Australian Resources Development Pty Ltd

Submission regarding GenCost 2023-24 Consultation draft

9 February 2024

The preceding chart is reproduced from GenCost23 Final, Apx Figure D.1, Historical maximum, minimum and average capacity factors for existing NEM wind generation (page 80).

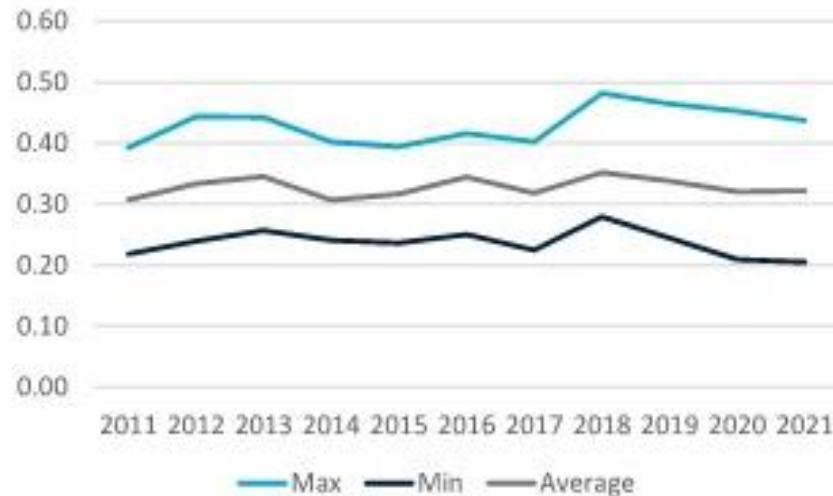
First, Draft GenCost23 Submission criticised the assumed CF range for wind in 2030 of 35% - 46%¹ as not related to market reality given even the minimum assumptions exceed the CFs currently being achieved. Thus, it was difficult to accept that such assumptions are “plausible”. The assumed CF range for wind in 2022 was 35% - 44%.

The GenCost23 Final response to the criticism was to change the 2022 and 2030 ranges to 29% - 48% - a 9% increase in the high range, thus moving further away from market reality. CSIRO justified its changes to the wind CFs as follows: *“The capacity factor range assigned to new build technologies are designed to be higher than the historical range. This is based on the view that new build technologies **may** include some technical advancements on their historical predecessors which mean they do not enter at the low range. Consequently, their low range capacity factor assumption is closer to the average capacity factor rather than the worst case. Specifically, we assume the low range value is 5% below the average. The high range assumption is that it equals the historical high range.”* (Page 51, emphasis added).

From the preceding chart, GenCost23 acknowledged that the “... *capacity factor for wind has been relative (sic) steady ...*” (Page 80).

Thus, CSIRO's historical wind data shows that no such “technical advancements” have occurred.

Secondly, the low range CF assumption is set at 5% below the historical average of \$33/MWh while the high range assumption is set at the historical high range.

□ The historical high range CF for wind is 48% which occurred in 2018 and has declined ever since.

If the approach of linking the CF range to the historical average is to be applied, it should be applied even-handedly which would result in the the high range CF assumption being set at 5% above the historical average, yielding a 38% high range wind CF.
